Submission ID: 217819

Objection to SSD-9409987: Moss Vale Plastics Recycling Facility

IMAGE 1 - Council's mapping of bushfire from [NSW Planning Portal](#) (note the grassland is not mapped as bushfire prone. Grassland has been required to be mapped as bushfire prone since the guideline changes in 2015).

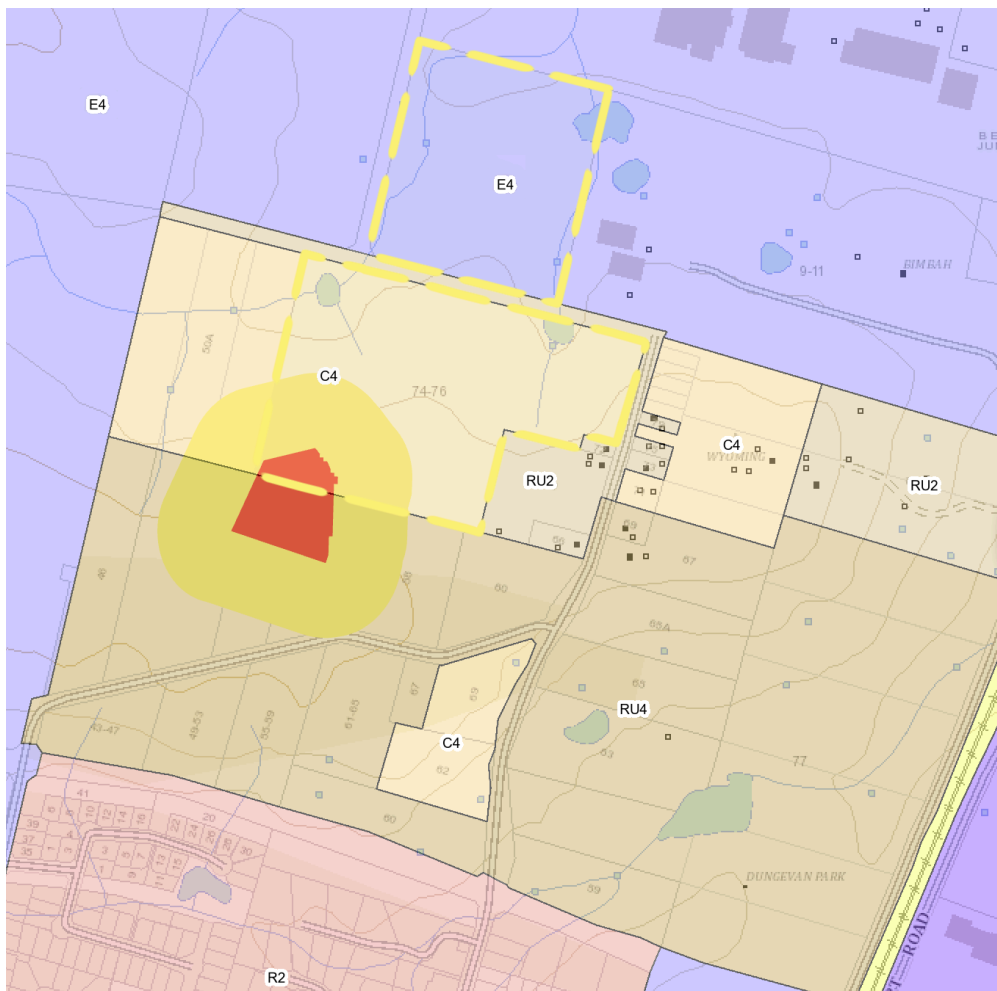
The proponent's reliance on bushfire mapping that has not been updated **since 2011** is deeply troubling.

The current (out-of-date) mapping gives the impression that the site is not bushfire prone, since the proposed works are outside of the bushfire overlay (red and yellow shading in IMAGE 1, above). This has allowed the proponent to claim that the site is not bushfire prone (EIS page viii) with no advice beyond initial RFS comments (letter dated 8

IMAGE 1 also provides an excellent visual of the incoherent patchwork of 4 zones in the surrounding area (see previous section).

This critical legal requirement has been overlooked. Wingecarribee's current nine-year-old bushfire mapping **may not be legal**.

IMAGE 2 - Under the current standards, areas of grassland should also be mapped as bushfire prone. For example, this is the up-to-date bushfire mapping for Marulan (in neighbouring Goulburn Mulwaree LGA), which is similar in character to

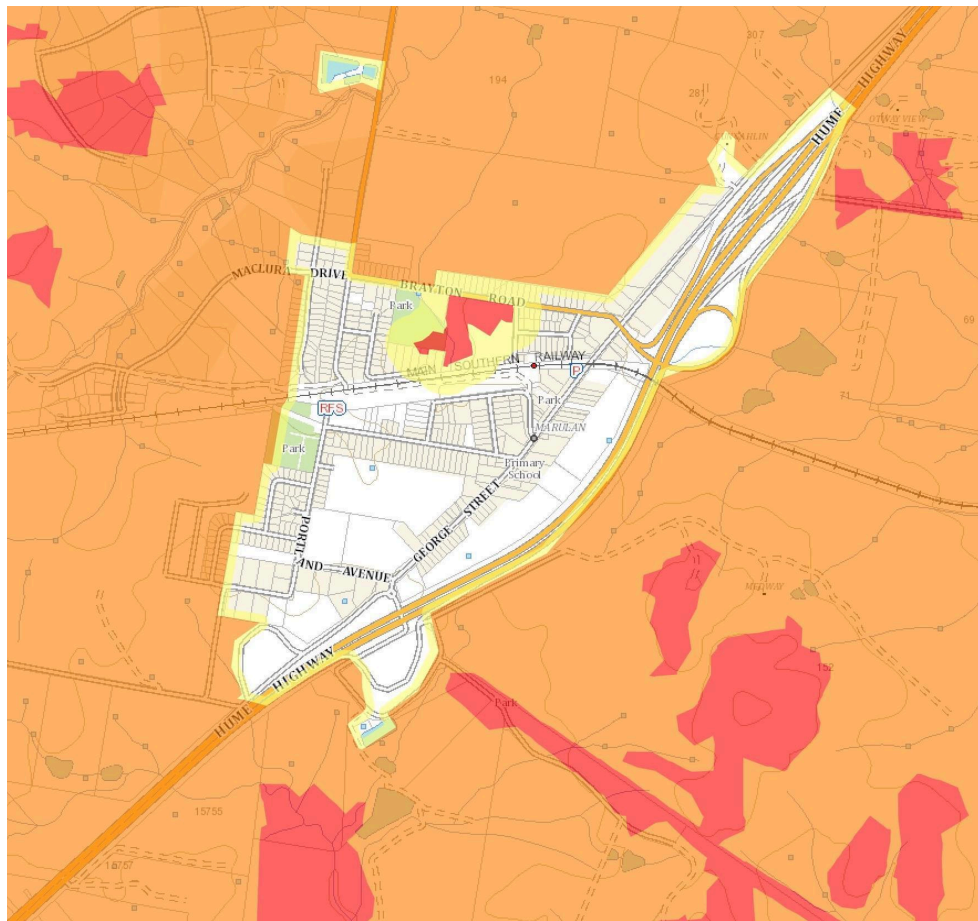
Current standards - the 2015 [Guide for Bushfire Prone Land Mapping](#) and PBP 2019 both **require** grasslands like those on this site (as per AS 3959 vegetation classifications) to be classified as bushfire-prone - i.e. the current Wingecarribee mapping that GHD has used is 9 years out of date.

the Plasrefine site. This map shows all the grassland around the village as bushfire prone (the orange, yellow, and red areas). If Wingecarribee's bushfire mapping were up to date, the entirety of the Plasrefine site would be coloured orange (bushfire prone) because of the grassland both on the site and on surrounding lots. GHD's technical reports don't mention bushfire at all - addressed in Section C.

IMAGE 3 - Screenshot from [RFS website](#). Showing that the block is, indeed, bushfire prone!

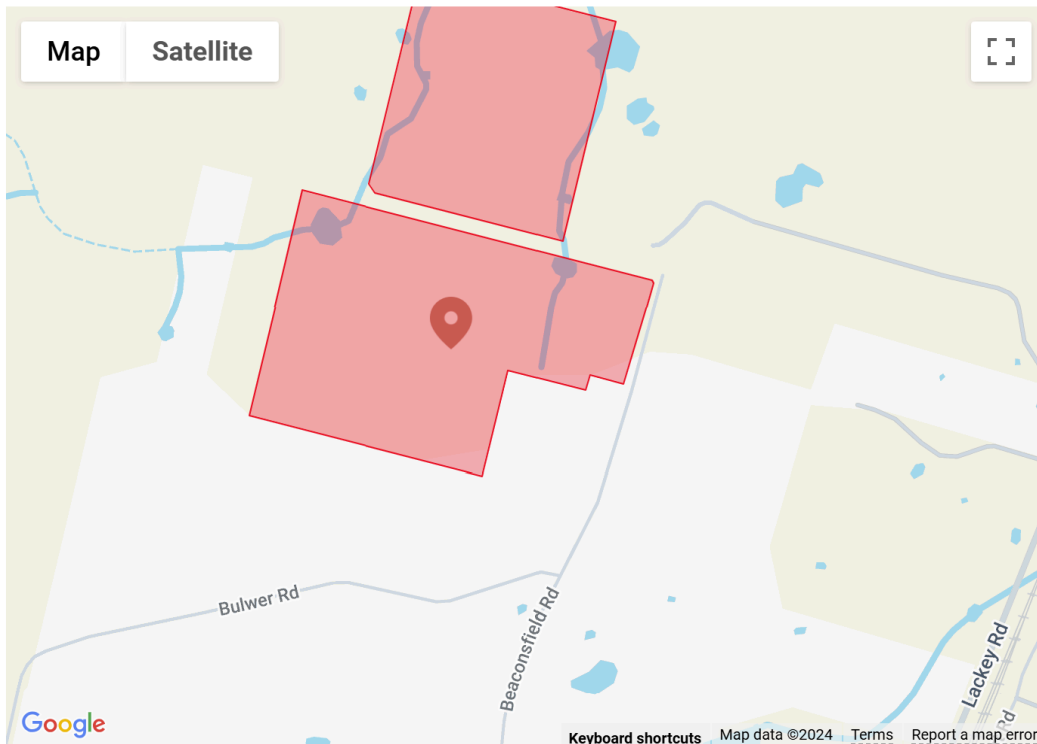
Although it is true that the bushfire overlay doesn't cover the *footprint* of the proposed Plasrefine facility, this doesn't absolve the proponent of the requirement to perform a bushfire assessment on the entire block. If **any** part of a lot is mapped as bushfire prone, this triggers a requirement for a bushfire assessment by an accredited Bushfire Planning & Design (BPAD) practitioner (Clause 2.2 of [RFS Planning for bushfire Protection \(PBP\) 2019](#)). Though the land is split into two portions either side of Braddon Road, it is a single lot. The presence of the bushfire overlay on *any* part of the lot triggers the assessment. The assessment method set out in Appendix 1 of PBP 2019 looks at *all* vegetation on the site, not just vegetation shown as bushfire prone on the bushfire prone land map.

While Section 4.14 of the Act may exempt the development from this kind of bushfire assessment, **the bushfire risk itself remains**. The proposal has not acknowledged this reality in any way, and has not proposed any alternative measures to address the threat in place of those in PBP 2019.

Asset Protection Zones (APZs): The 'Grassland Deeming Provisions' of [Planning for Bushfire Protection \(PBP\) 2019](#) require a 50m Asset Protection Zone to achieve a Bushfire Attack Level of zero (i.e. BAL-LOW). Where a building is constructed to suit a higher Bushfire Attack Level, a smaller APZ can be implemented. For a 'Special Fire Protection Purpose' development, the minimum APZ for grassland would be 36m on the uphill and flat sides (West, South, East) side and 55m on the downhill side (North).

The proposed buildings are set back from the northern and southern boundaries by less than these distances, leaving no room for adequate asset protection zones in these directions. To the east and west, flammable vegetation (including eucalyptus trees planted at a rate of 2.5 per square metre!) is proposed within ~10m of the proposed buildings. This density of planting is not compatible with establishing an asset protection zone.

IMAGE 4: Side by side comparison of generous curve radius required by fire fighting vehicles and tight corners in the proposed site plan.

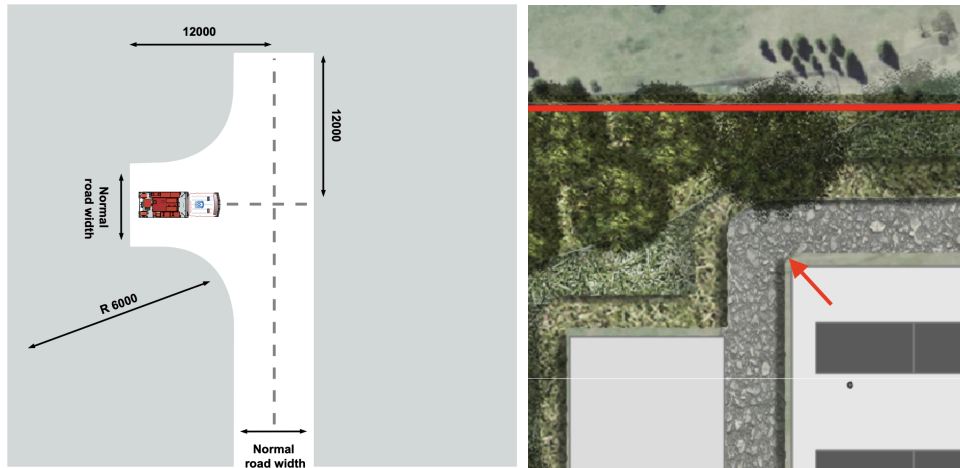
Compliant Driveways: Narrow site driveways with tight corners, exacerbated by parked cars and overhanging trees, fail to meet firefighting vehicle access standards. Planning for Bushfire Protection requires an inner curve radius of 6m while the proposal appears to have corners at the northern end with zero curve radius.

IMAGE 5 - Architectural Elevation drawings from **ADR Appendix J - Architectural Plans 26 September 2023**. Fairly conceptual early elevations, showing Building 1 as our example.

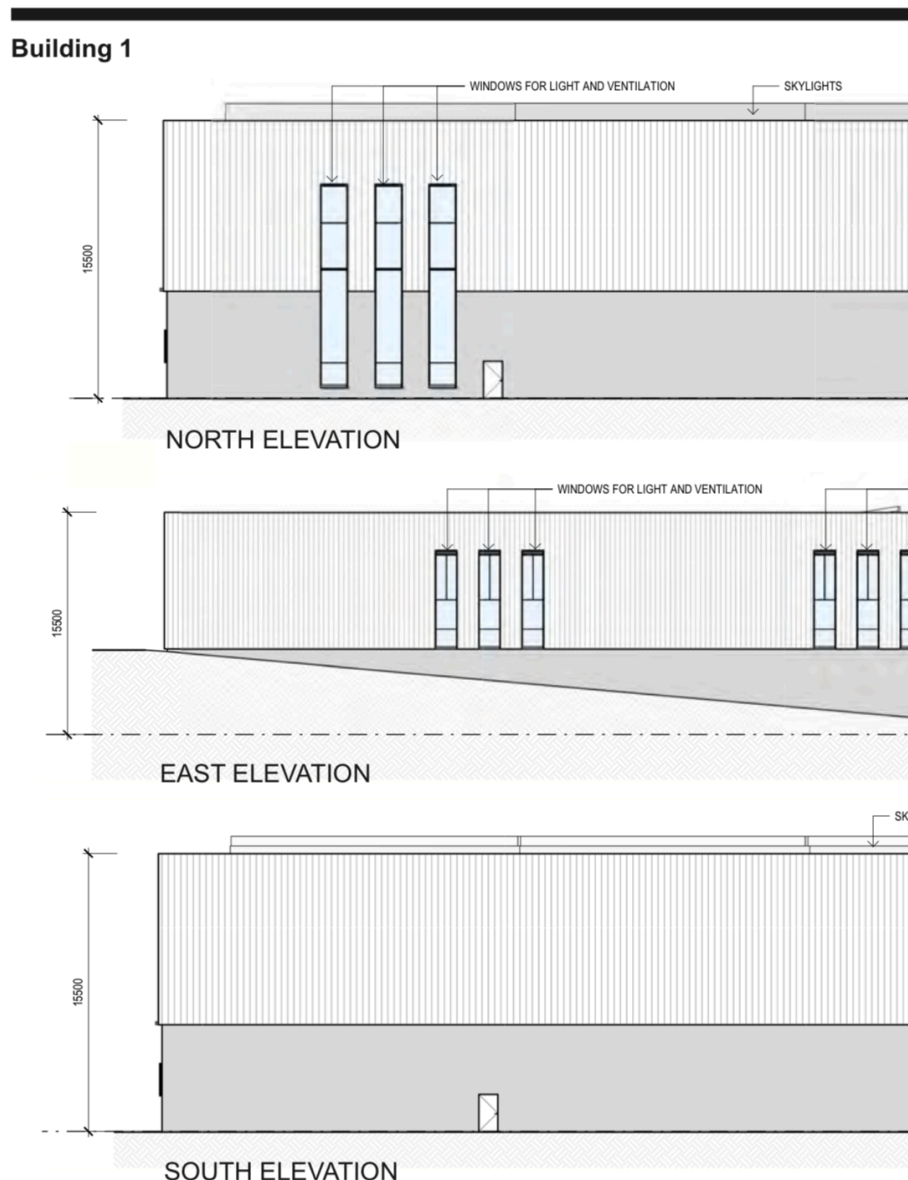
The earliest elevation drawings show no indication of smoke stacks or roof vents, with ventilation windows instead depicted. These windows later disappear as the proponent moves towards a fully enclosed facility. This omission is notable, given the potential visual and environmental impacts of the stacks.

IMAGE 6 - Architectural Elevation Drawings from **Amendment RTS Updated Architectural Plans - 01 Feb 2024**. Showing stacks and vents on the elevation drawings of Building 1. This document introduces 4 stacks of inconsistent heights across various images in the drawing set (see below).

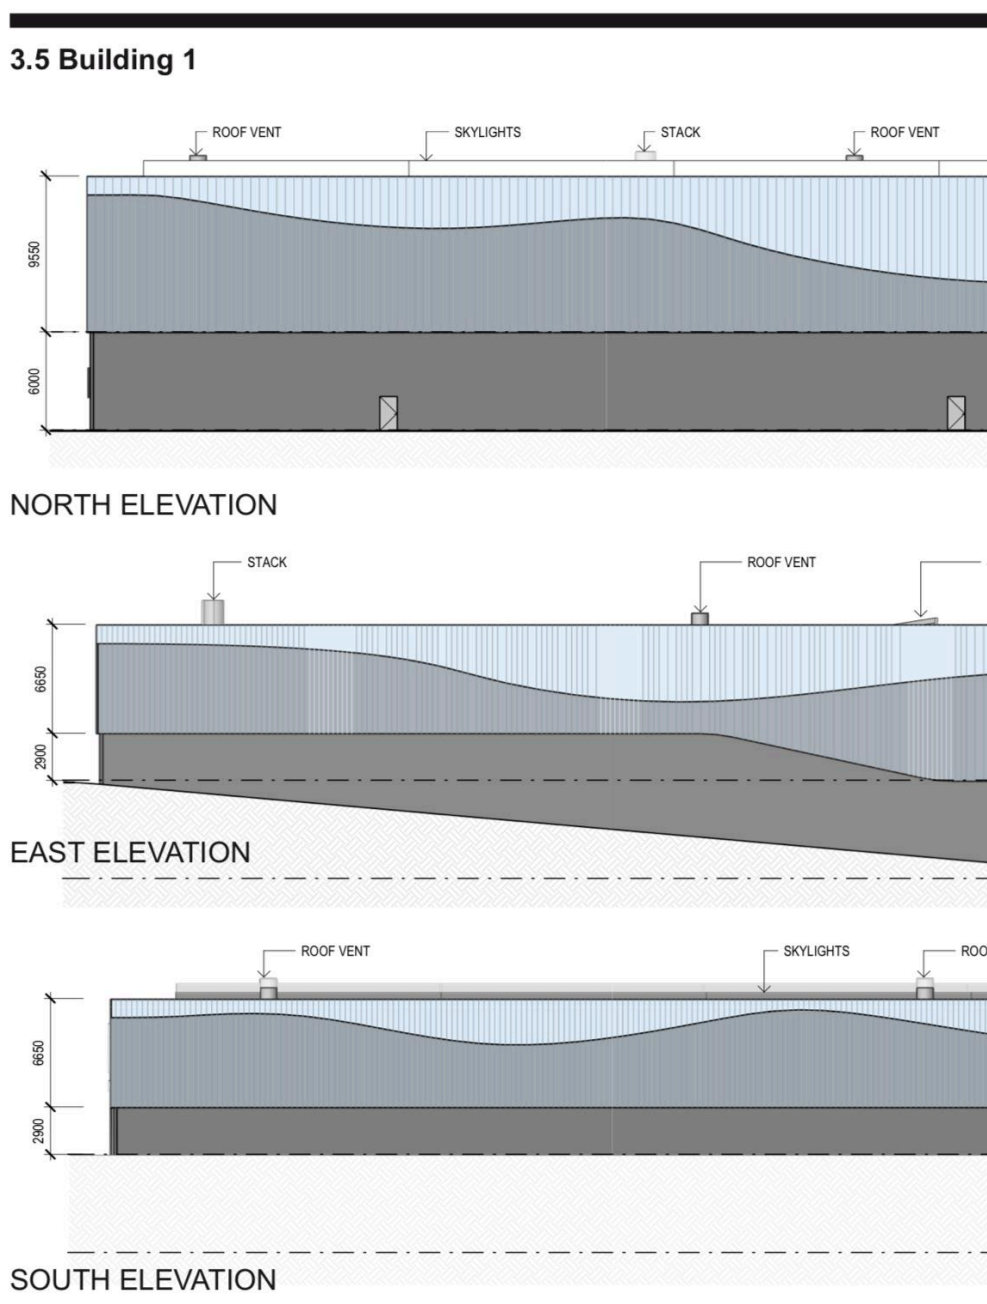
The 01 Feb 2024 set is the most transparent when it comes to the stacks and vents. They are also shown (albeit significantly taller) on this axonometric image from the same document:

It is also worth noting that the axonometric (IMAGE 7, 8, 10) does not match the south elevation of the architectural drawings in this same document (IMAGE 6) which shows a diminutive pair of stacks, not much taller than the 'roof vents'. These have not been dimensioned, presumably to allow for flexibility in the final design - to address regulatory or operational needs. This lack of clarity raises questions about transparency.

IMAGE 8 - Axonometric - Close up with 4 stacks indicated.

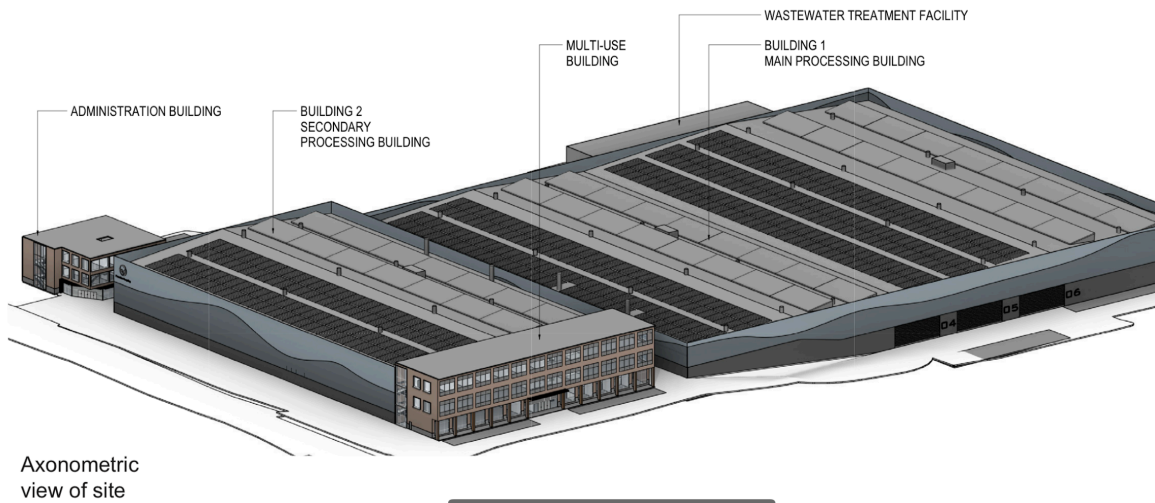
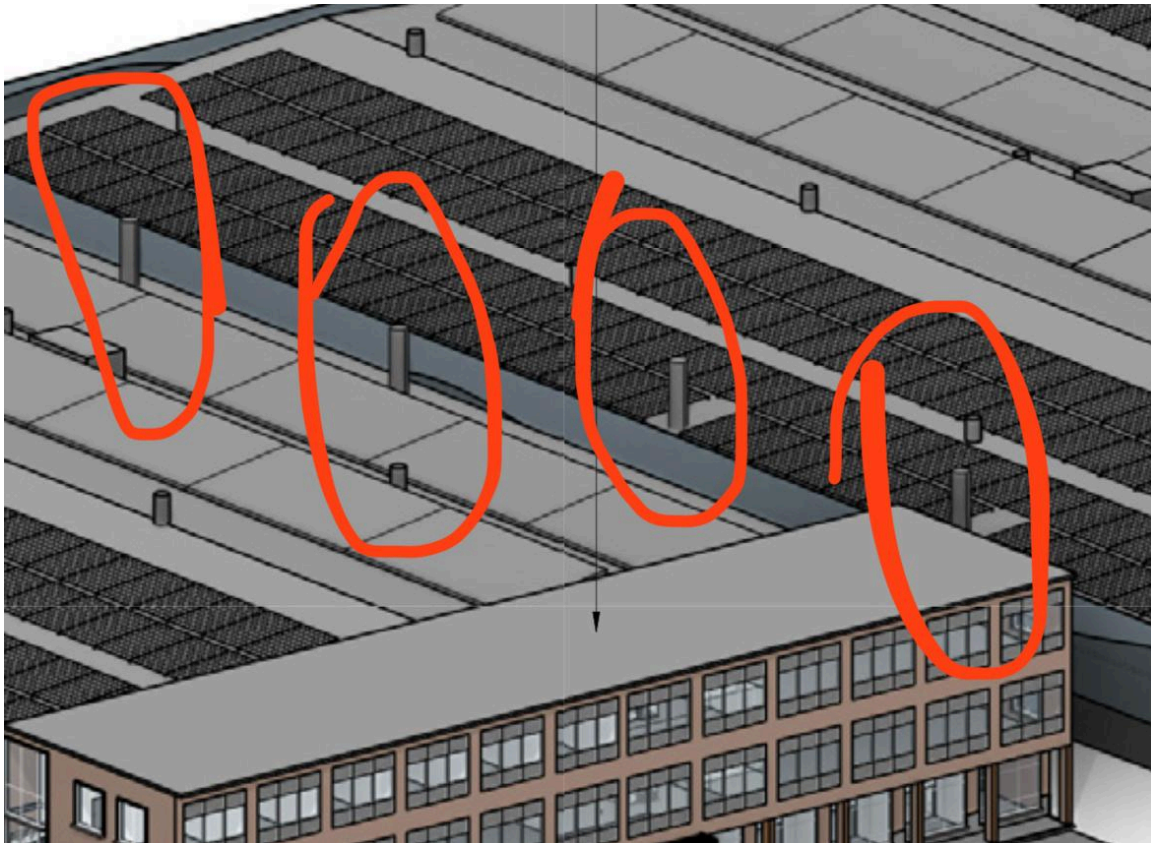
In the **RTS Updated Architectural Plans (Feb 2024)** (IMAGE 6, IMAGE 7), four stacks are depicted across the two main buildings. However, during Day 1 of the IPC meetings, contradictory statements were made: Sofie Mason-Jones from GHD confirmed a **2m height for the factory's two smoke stacks**. Ms Mason-Jones also uses the terms 'stacks'

IMAGE 10 - The axonometric shows the stacks just under 5m tall (assuming a height of 9550mm for the building on the southeast corner as per the architectural drawings in IMAGE 6). Helpfully, axonometric images are drawn without perspective, allowing visual comparisons like this.

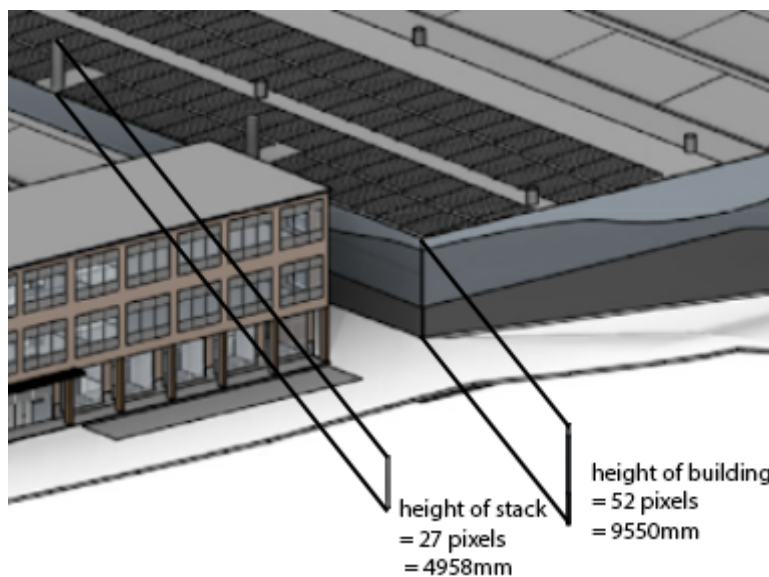
If we add together the 9550mm of the structure (as per the architectural drawings - IMAGE 6) and the 4958mm of the stacks (from IMAGE 10), we come to a total height of 14.5m, which is under the 15.5m maximum nominated by Gamble. As such a 5m stack height is likely if this building is ever constructed. A 6m height would, however, also be possible. Again, this is at odds with Sofie Mason-Jones' statement to the IPC on Day 1 of the IPC meetings.

IMAGE 12 - Architectural Elevation Drawings from **30 April 2024 RFI Response Appendix C Preliminary Design Report_Final** (page 27).

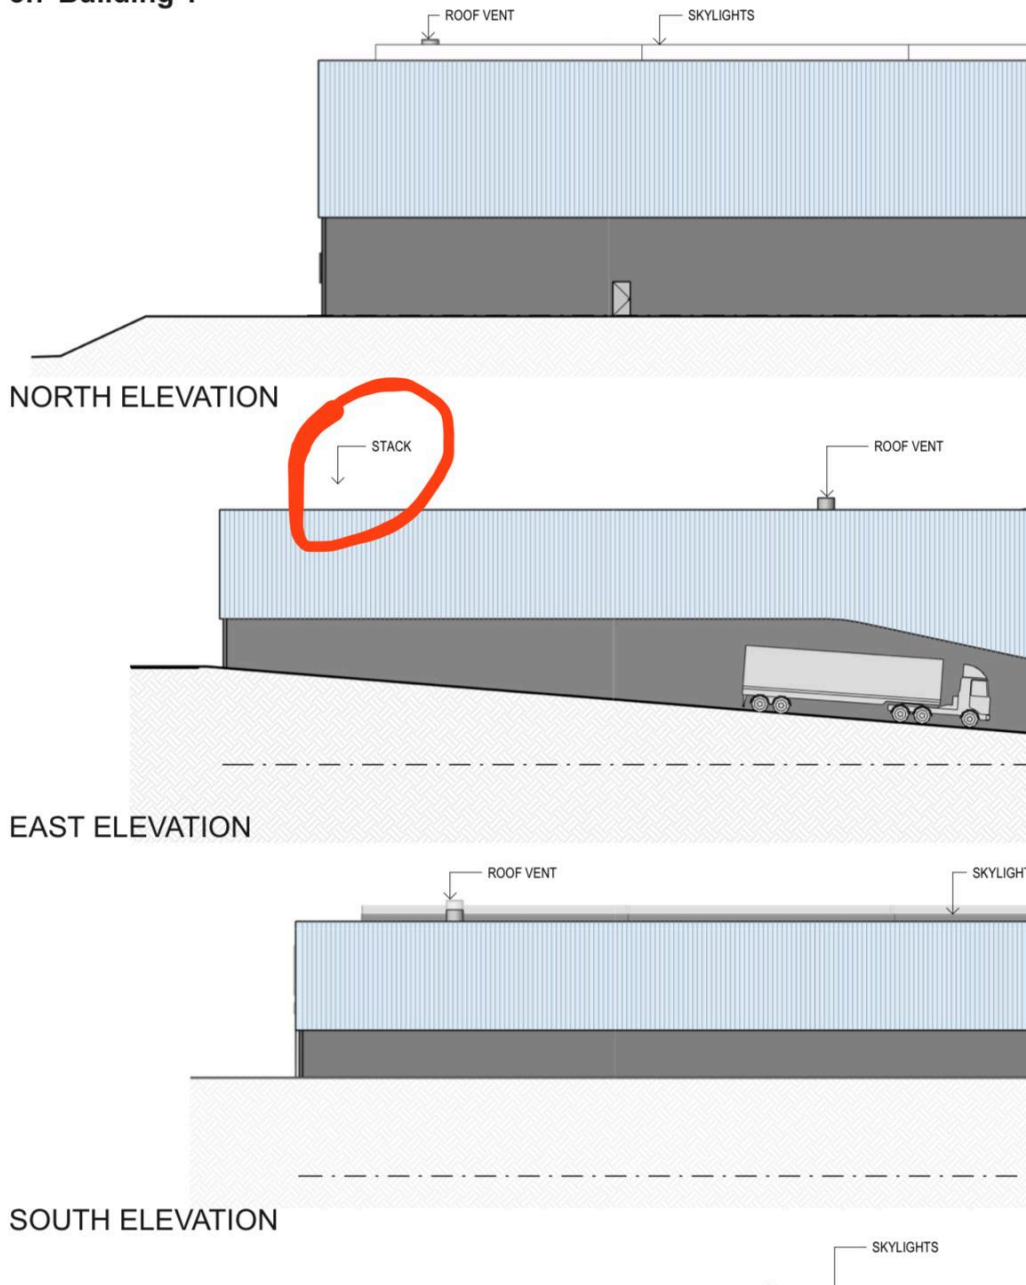
The most recent version of these Building 1 Elevations (IMAGE 12) now show no stacks or building heights. This is despite these details being evident on previous versions of the plans (IMAGE 6). However, an artefact does remain (circled in IMAGE 12). Typically when we see artefacts like this on Revit-generated drawings, it's from deleting something off the 3D building model and then forgetting to also remove the label on the 2D page view.

- Have these stacks been formally removed from the design or will they reappear in updated plans in the future?
- What happened between February and April that encouraged this alteration to the plans?
- Were the stacks and building height dimensions removed to downplay their visual impact?
